Entergy Nuclear Generation Co.  
Pilgrim Nuclear Power Station  
600 Rocky Hill Road  
Plymouth, MA 02360

Docket No. 50-293  
License No. DPR-35

**MODIFICATION OF TECHNICAL SPECIFICATION CHANGE SUBMITTAL  
CONCERNING PRESSURE-TEMPERATURE LIMIT CURVES**

**PILGRIM REACTOR VESSEL PRESSURE-TEMPERATURE LIMITS**  
**HYDROSTATIC AND LEAK TESTS**

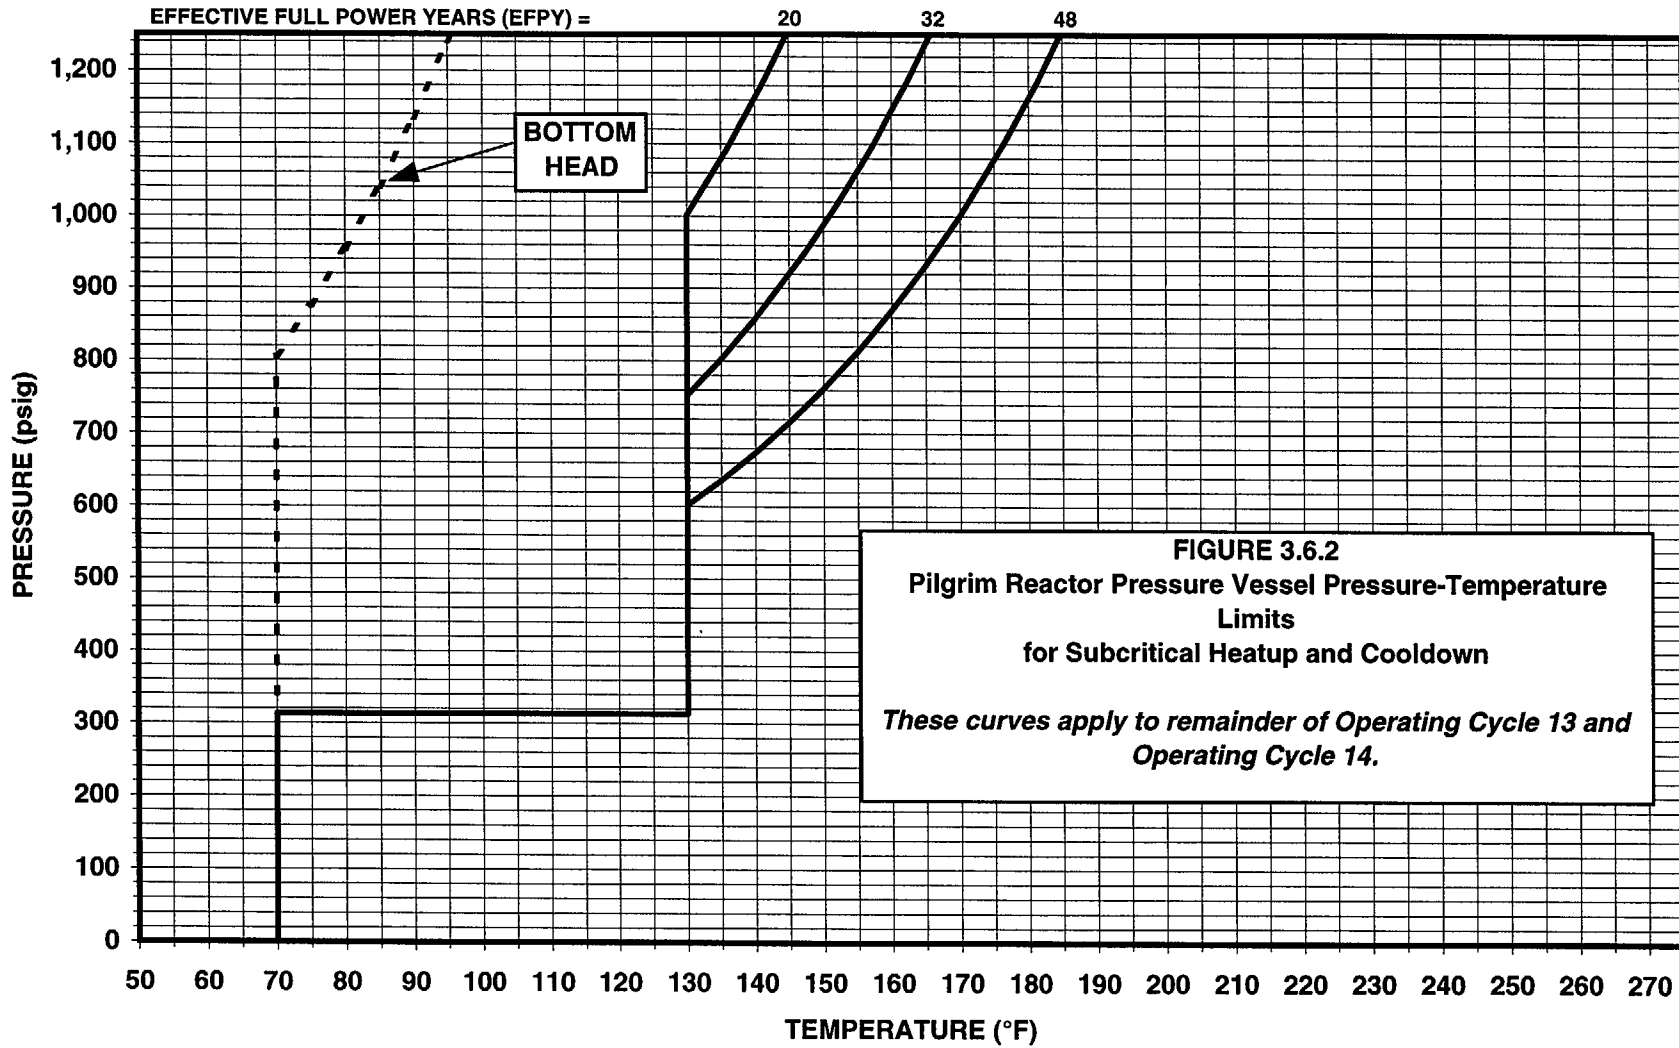
This proposed change to Pilgrim's November 22, 2000, amendment request adds a footnote to Figures 3.6.1, 3.6.2, and 3.6.3 of Pilgrim's Technical Specifications that states:

**These curves apply to remainder of Operating Cycle 13 and Operating Cycle 14.**

During NRC review of the amendment request, Pilgrim learned that a new methodology for calculating neutron fluence was soon to be approved by the NRC for industry use. The November 22, 2000, amendment request curves used an approved fluence methodology that may be superseded by the new methodology. Pilgrim, therefore, is amending the November 22, 2000, amendment request by limiting application of the proposed curves to essentially one cycle, that is, the remainder of operating cycle 13 and operating cycle 14. Operating cycle 13 is nearly over; operating cycle 14 is scheduled to commence at the conclusion of refueling outage 13, currently scheduled for May, 2001.
